# **MORGAN AND MORECAMBE OFFSHORE WIND FARMS: TRANSMISSION ASSETS**

**Applicants' Response to Secretary of State's Letter Dated 12 March 2026**

**Deadline: SoS Letter**  
**Application Reference: EN020028**

**Document Reference: S\_SoSQ\_9**

Figure 1-5: Bird strike management measures

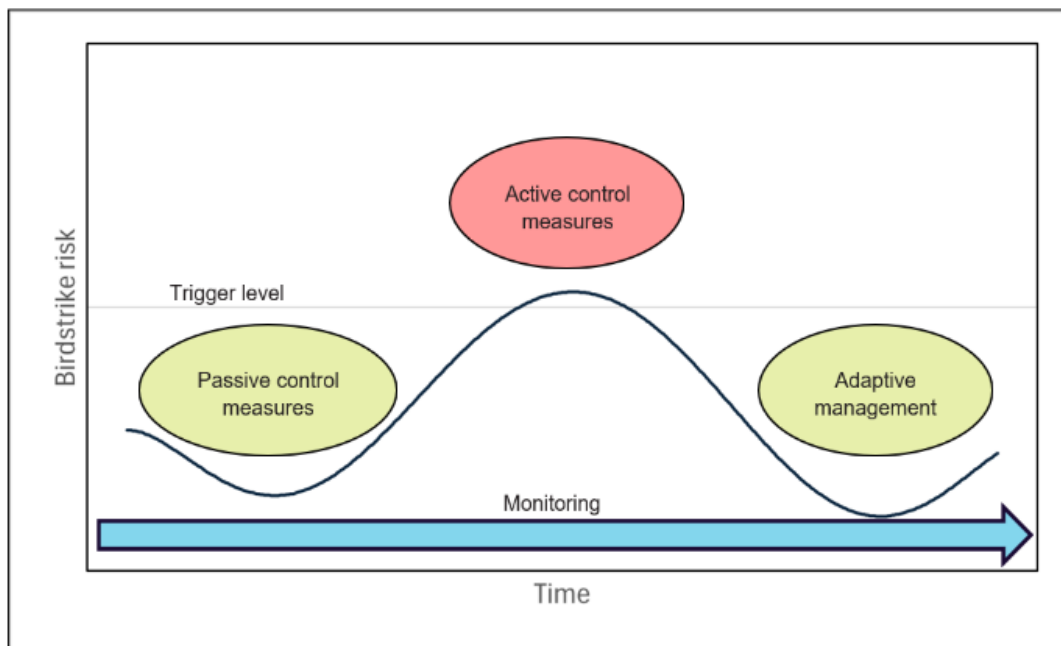
*9. The Secretary of State notes that DIO's post-Examination submission dated 6 November 2025 also states "For a management plan to be effective in mitigating the*

*potential increase in birdstrike risk it would need to ensure that no hazardous birds are utilising the Newton-with-Scales site above the levels that are currently present there". DIO and the Applicants are requested to comment on whether the DIO's concerns could be resolved by the oWHMP defining bird population levels and committing to triggers/thresholds for active management. The Applicants are requested to provide further information on triggers/thresholds for active measures within the oWHMP and whether it could commit to such thresholds at this point. The Secretary of State encourages the Applicants to consult with Natural England on the triggers/thresholds for active management to ensure they are set at a level which still allows the mitigation areas to be effective from an HRA perspective.*

1.3.2.40 The Applicants agree with DIO's position that for a management plan to be effective it would need to ensure that measures were in place to ensure hazardous birds utilising the south of Newton-with-Scales mitigation area did not increase above an agreed threshold (trigger levels). This is demonstrated throughout the Applicants' Examination submissions as well as within the bird strike risk assessment for Warton Aerodrome (see section 1.3 of Appendix C of the oWHMP (S\_D3\_8 F05)). The Warton Aerodrome bird strike risk assessment considers trigger levels as an integral part of the management plan for bird strike risk. Extracts from the oWHMP are provided below to summarise the Applicants' position.

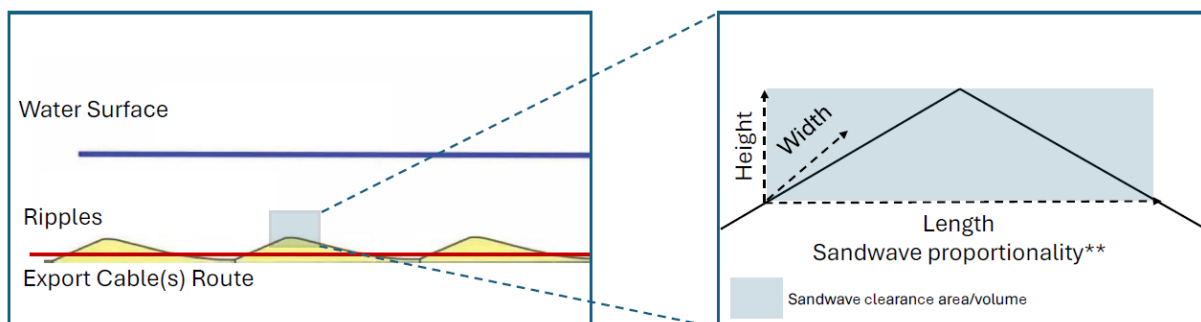
*15. The Applicants are requested to update Table 3 of the Cable Specification and Installation Plan [REP6-097] (and any other relevant documents) to include the Maximum Design Scenario ("MDS") for sandwave clearance by area (m<sup>2</sup>) and to provide an explanation of how the MDS for sandwave clearance by volume (m<sup>3</sup>) has been calculated.*

1.5.2.2 The Applicants have updated Table 3 of the Outline Offshore Cable Specification and Installation Plan (CSIP) (J15/F05) to include the Maximum Design Scenario (MDS) for sandwave clearance by area

(m<sup>2</sup>). The Applicants can confirm that the update to the Outline Offshore CSIP does not need to be reflected in any other documents.
